## Addendum No. 2

Reference: Mechanical/Electrical/Plumbing Upgrades – Miller Administration Building  
Weber State University – Ogden, Utah  
DFCM Project No. 14031810

## ADDENDUM #2

Project: Weber State University  
Miller Administration M.E.P. Upgrades  
3848 Harrison Boulevard  
Ogden, Utah 84401

**AE101**

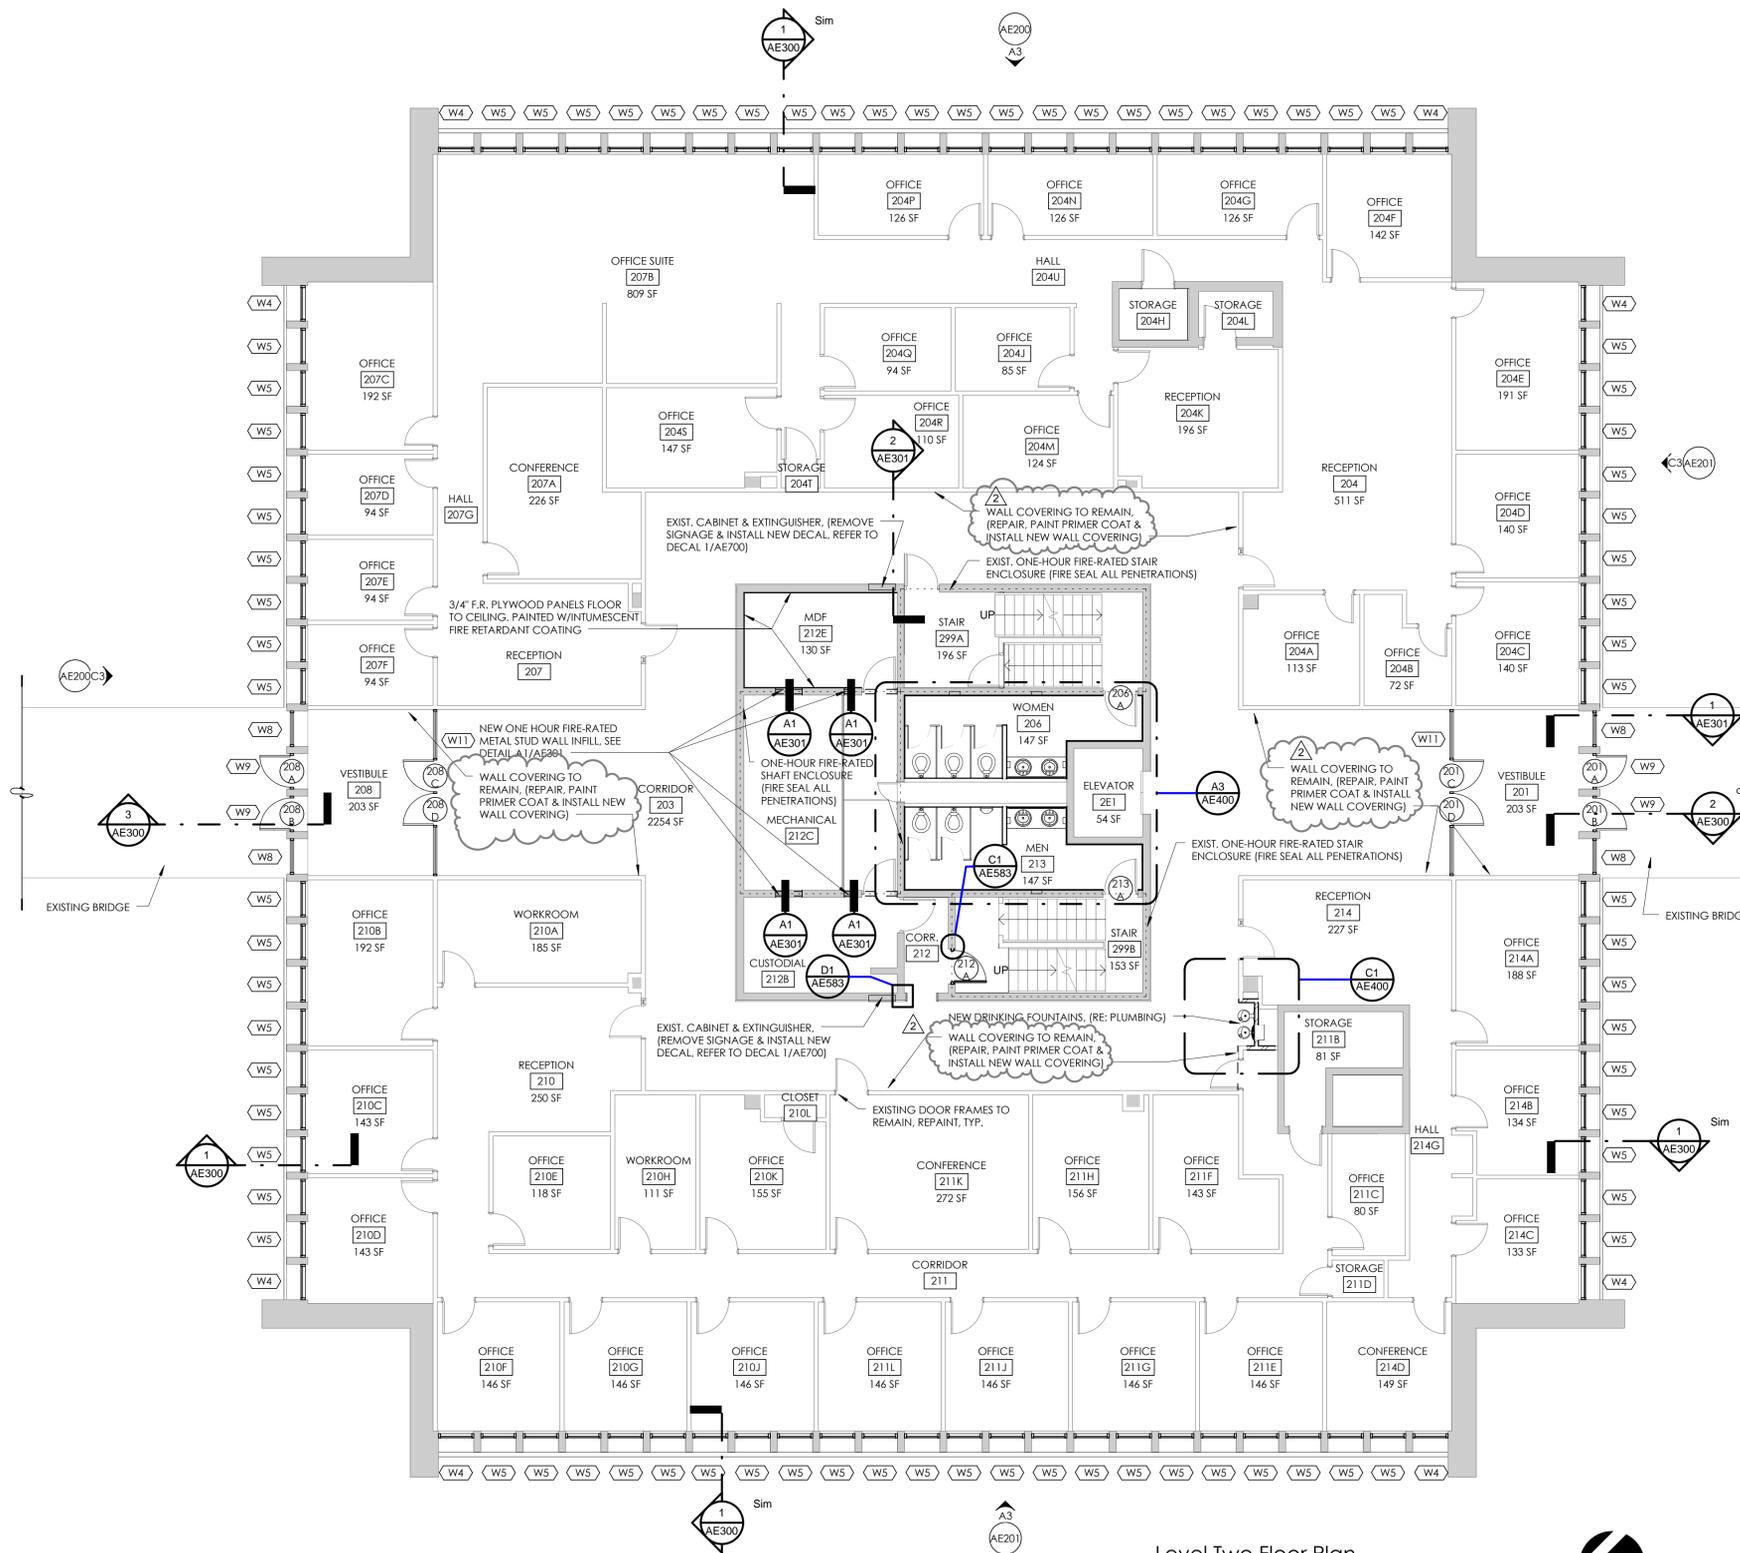
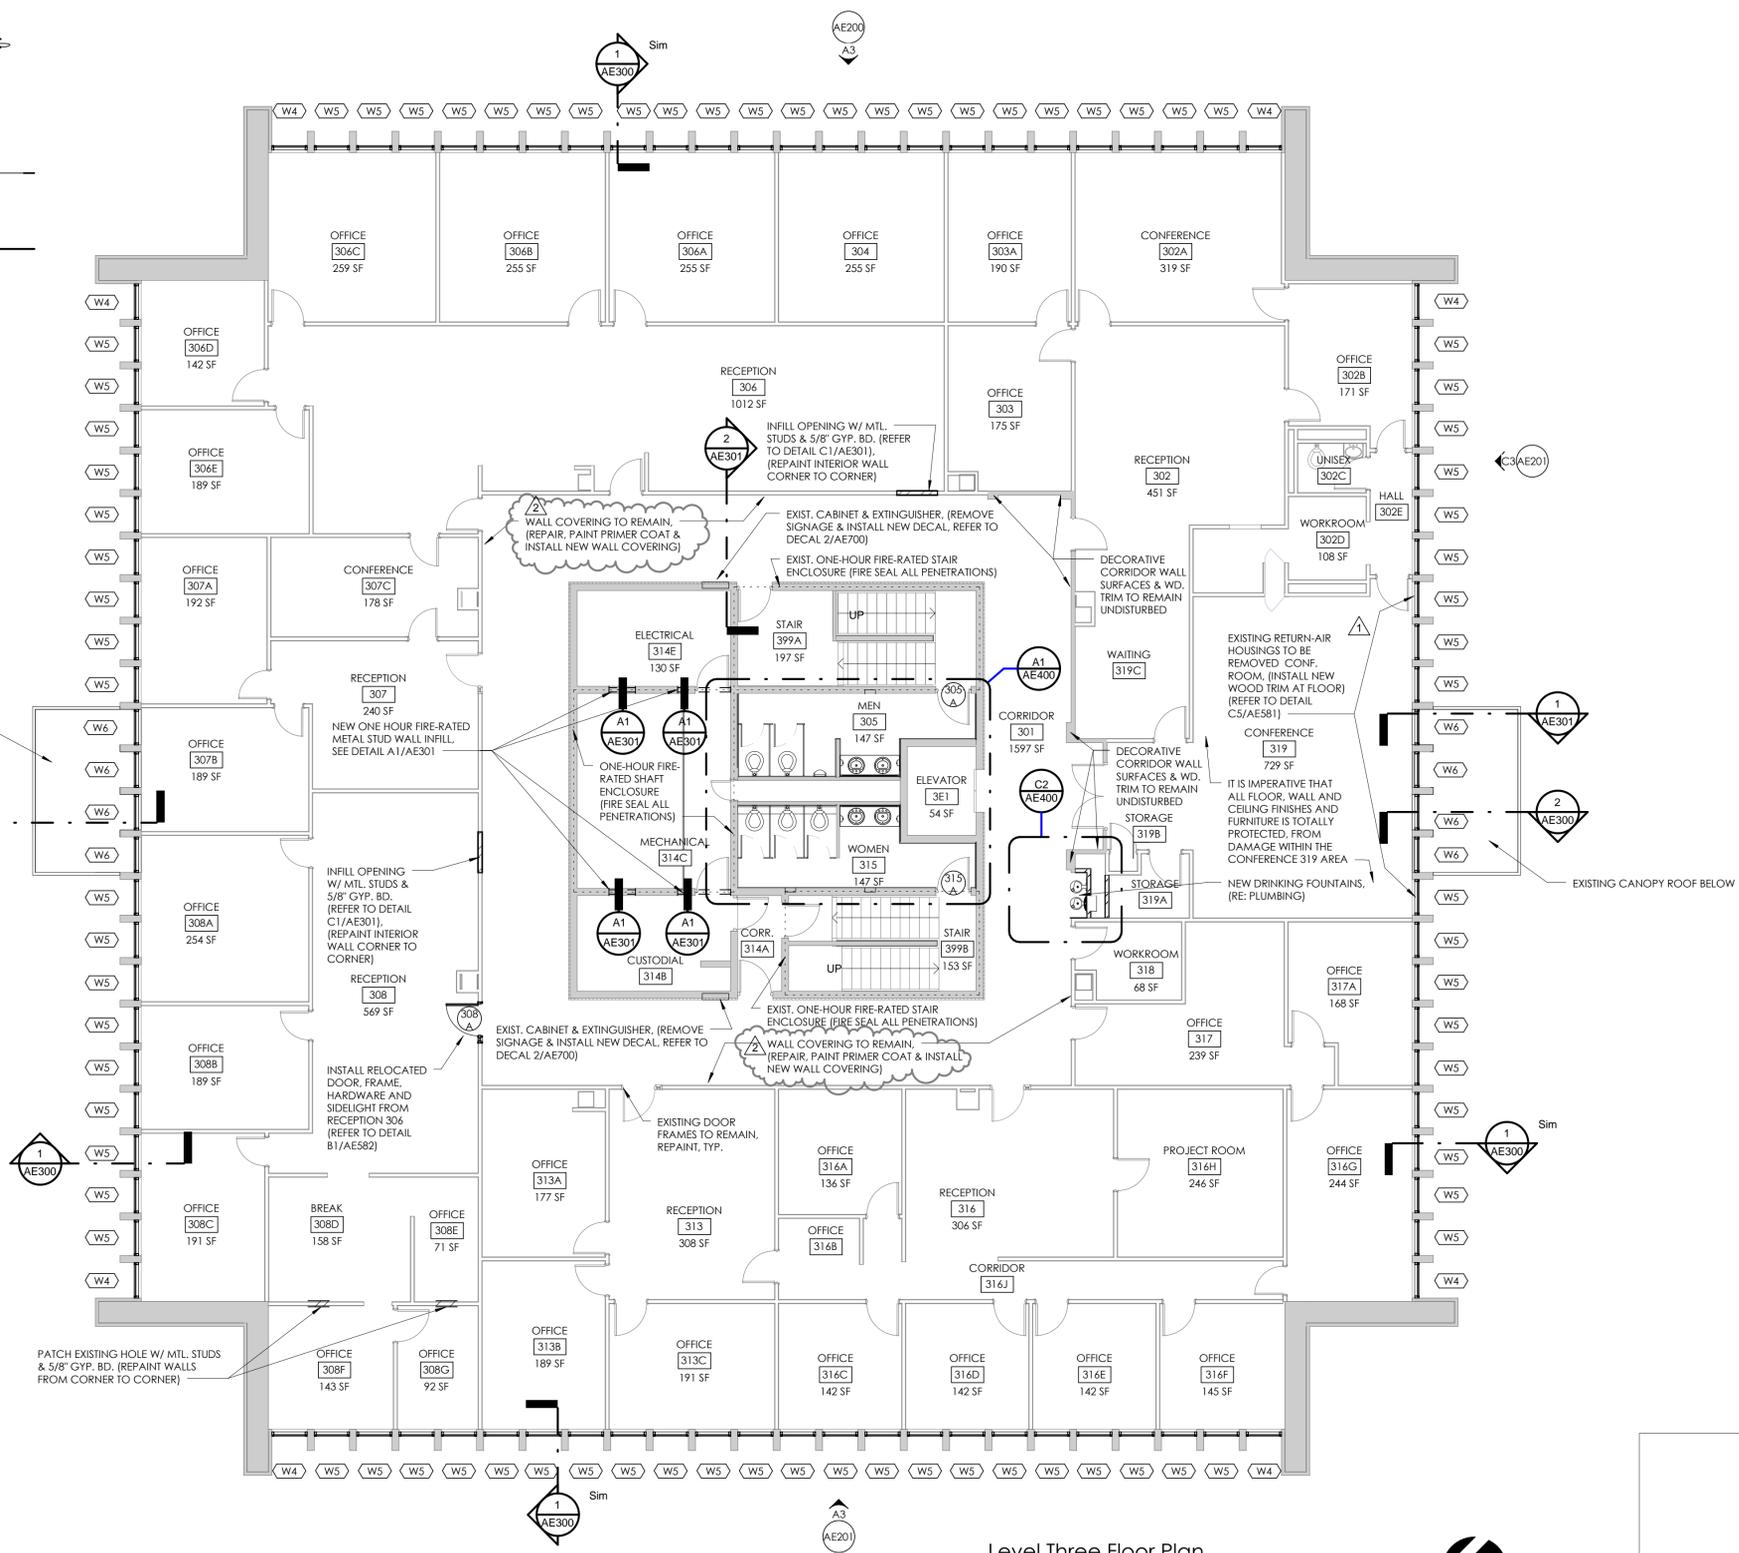
QUESTION: *"Ceiling Detail A4/AE541 calls for "Remove and replace existing 5/8" Gyp Bd. This detail is found on the RCP AE122 on AE101 indicates a skim coat over existing drywall. Which should I include?"*

ANSWER: The existing drywall is to remain and the existing wall covering is to remain. The skim-coating of the existing gypsum board is omitted from the project. The existing wall covering is to be repaired, prime painted and new wall covering installed. **(Refer to Addendum #2, Architectural Addendum Item #10 and Item #12, and Refer to the attached drawing AE541).**

**C1** Level 2 - Enlarged Drinking Fountain Plan  
3/8" = 1'-0"

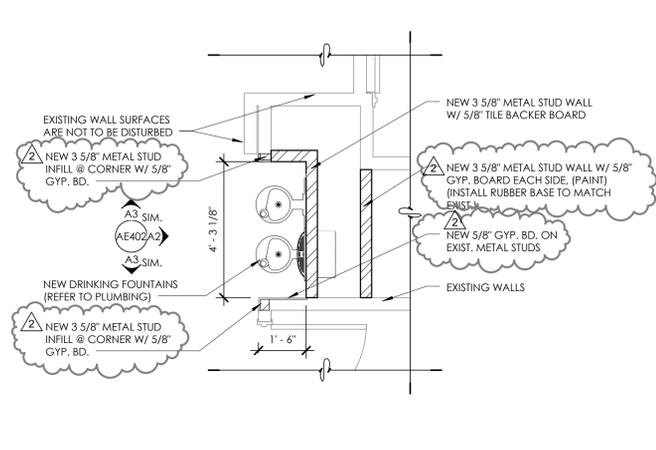
The wall finishes located near the new drinking fountains on level two and level three are clarified. **(Refer to attached drawing plans C1/AE400 and C2/AE400).**

**B3 CEILING DETAIL LEVEL 1**  
 3" = 1'-0"

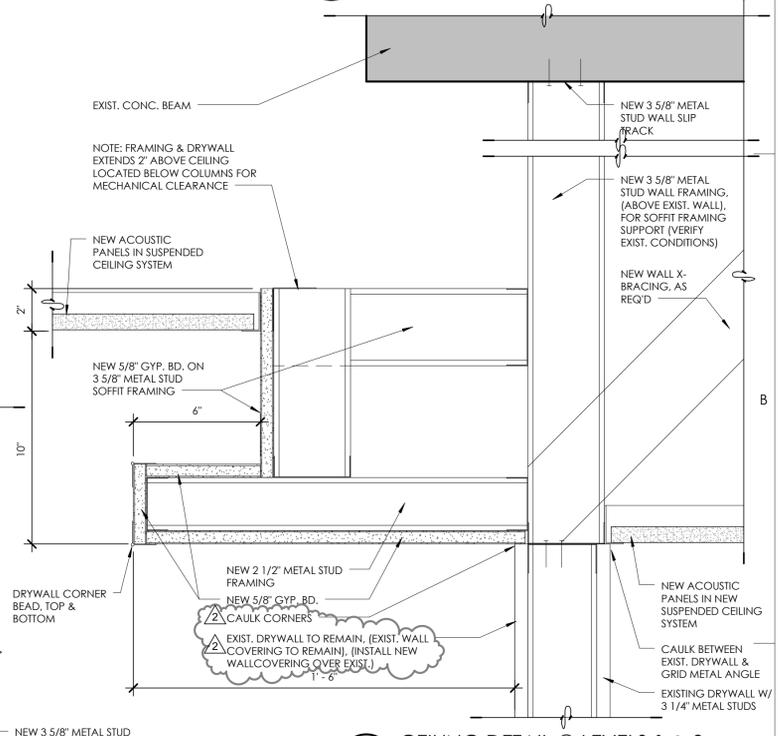
Omit the new 1/4" gypsum board overlay in the corridors of level one. The existing corner guards are to remain, and they are to be painted. **(Refer to attached drawings AD100, AE100, Wall Section 2/AE301, Ceiling Detail B3/AE541, Details D1/AE583, D2/AE583 and D3/AE583).**

**A4 CEILING DETAIL @ LEVEL 2**  
 3" = 1'-0"

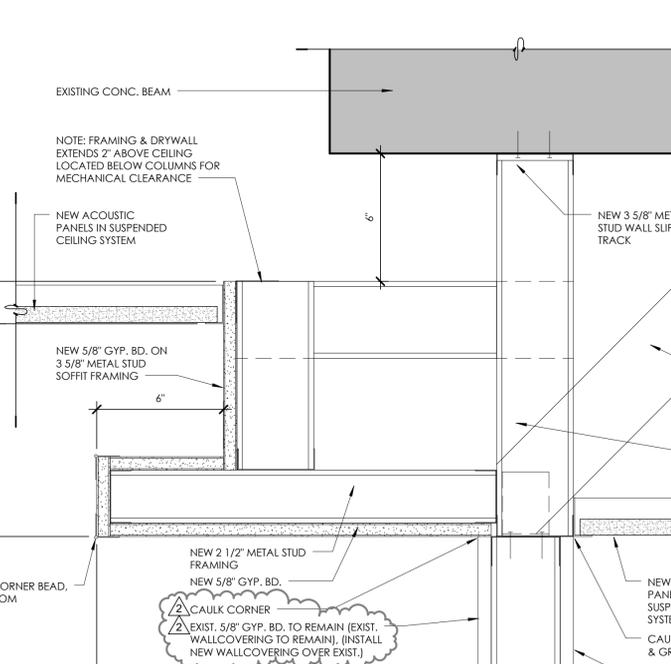
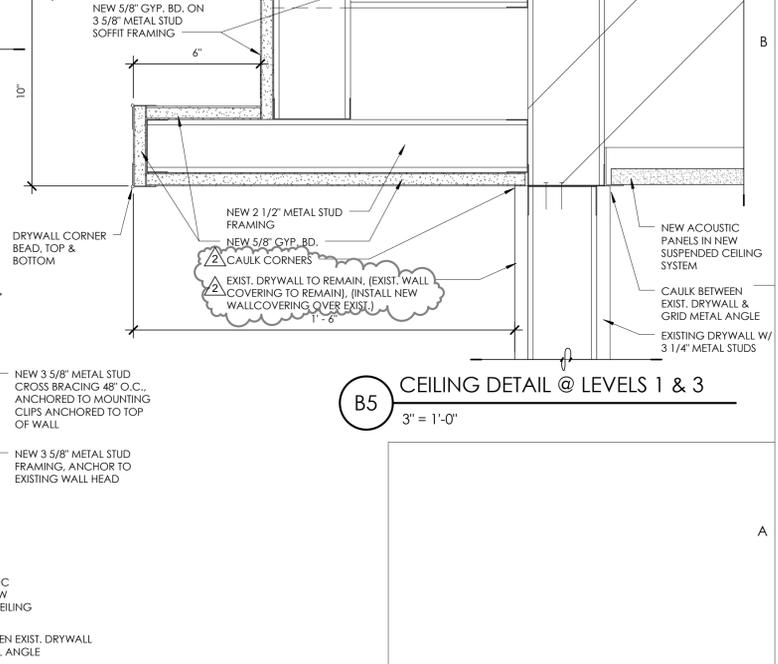
QUESTION: *"Looking on AE121 south corridor, South wall calls for an A type top of wall condition and also A4/AE541 in the same location. We are assuming the A4/AE541 detail would be required to hold the drop so my question is does the A4 condition need to extend from the drop to the end of the wall at the gyp ceiling condition or can the A or D condition Bracing only be used in these locations. This condition also occurs on AE121 & 122. "*

ANSWER: We have indicated the existing top of wall conditions, as close as we can determine with the limited site ceiling access in some building locations, by providing the top of wall / ceiling details on AE542. There are locations at the existing top of wall conditions that have existing wood nailers installed for mounting the ceiling grid perimeter angles. This occurs sporadically at various locations through out the building. We indicated the A4/AE541 detail for the new dropped ceiling at the corridor walls. The "A" Ceiling Detail on AE542 indicates top of wall locations that we have observed existing wood nailers installed. Note, there may be other locations that have this condition that is not accessible for field verification at this time. The intent is to try to leave the wood nailers, if possible, since they are mounted to the existing ceiling grid angles. The new wall bracing at the corridor wall would be similar to detail A4/AE541.

**AE542**

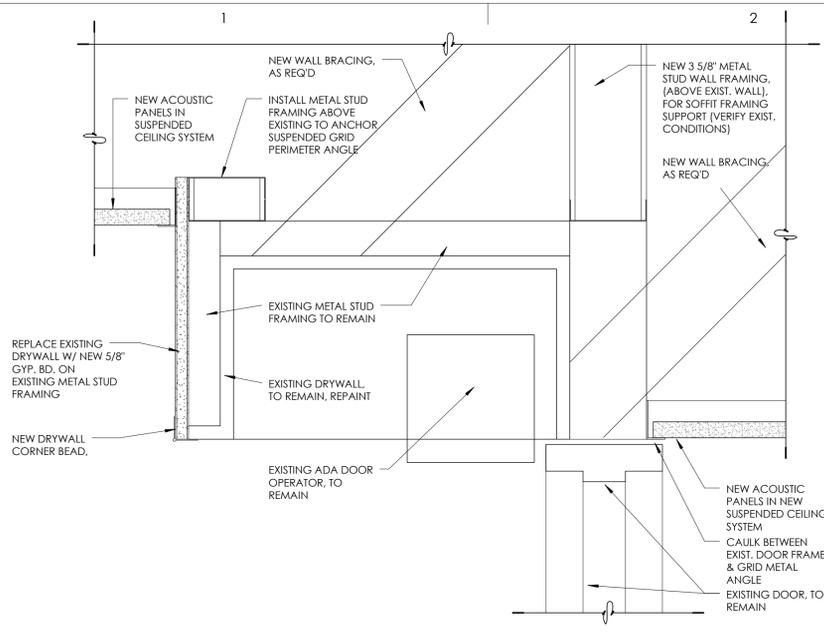
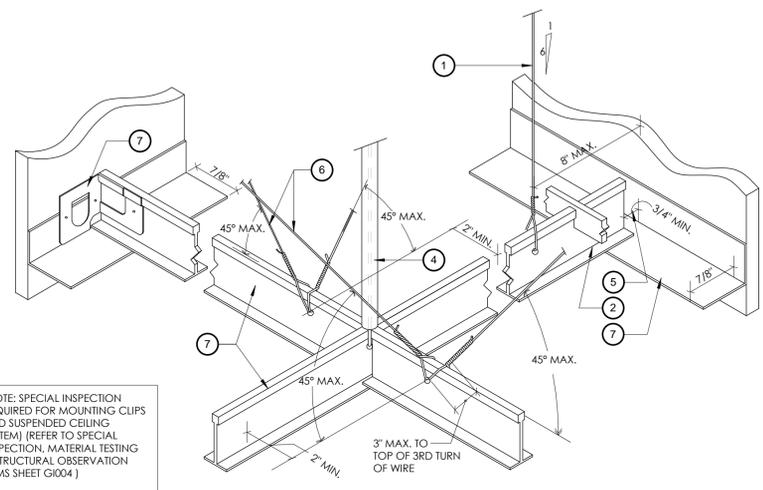
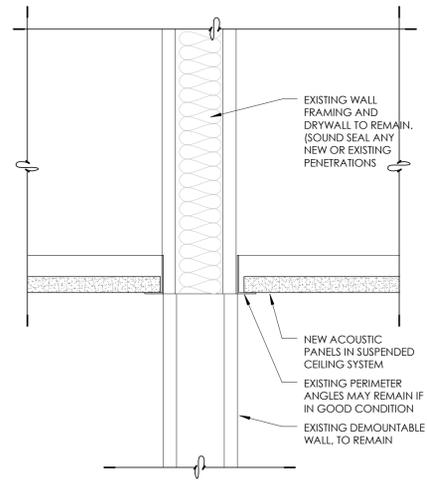
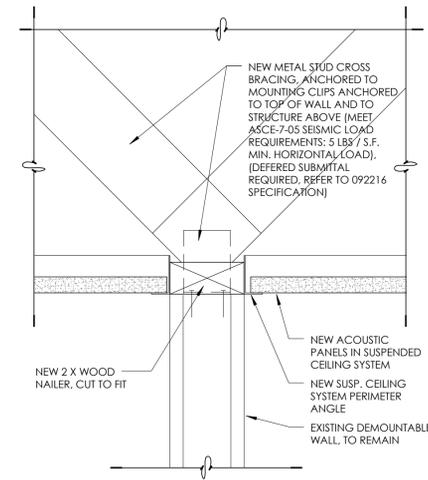
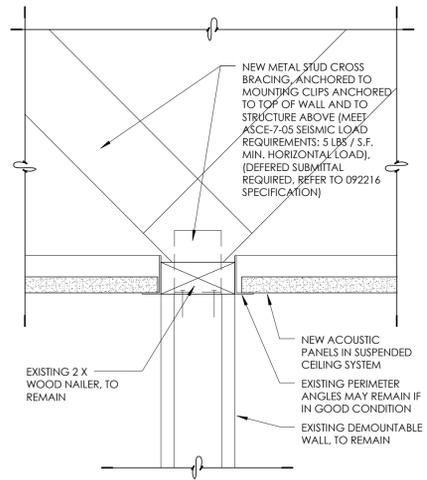
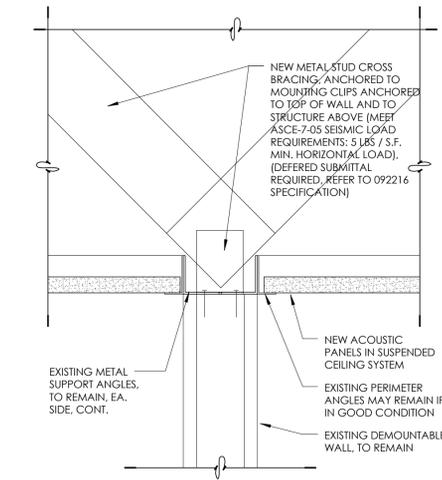
QUESTION: *"Note on wall ceiling details, AE542 calls for bracing back to the structure on most of these walls. This note calls for a "Deferred Submittal Required" Any thoughts on what gauges, spacing and clips required to the top of wall and at the deck? Without paying for the engineering on my side is just a guess."*

QUESTION: *"On each of the Reflected Ceiling plans AE120, 121 & 122 the "Ceiling Plan Legend" refers to AE582 for top of wall which we are assuming was meant to say AE542."*

ANSWER: There is existing wall bracing located on some of the existing interior walls that have been part of a building remodels in the past. Some of the original building interior walls do not have any wall bracing. With the extensive

ANSWER: The "Ceiling Plan Legend" reference is to be changed from AE582 to AE542.

PHOTO OF EXISTING SIGN FOR MATCHING EXISTING

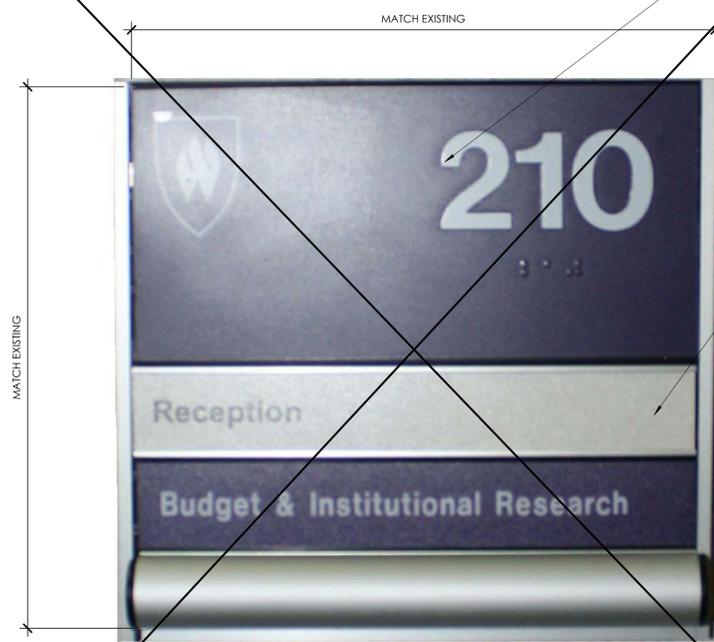
The new signage indicated in the Signage Schedule on Drawing AE700 will be provided and installed by Owner. **(Refer to attached sheet AE700).**

OMIT SIGNAGE, (OWNER WILL PROVIDE & INSTALL SIGNAGE)
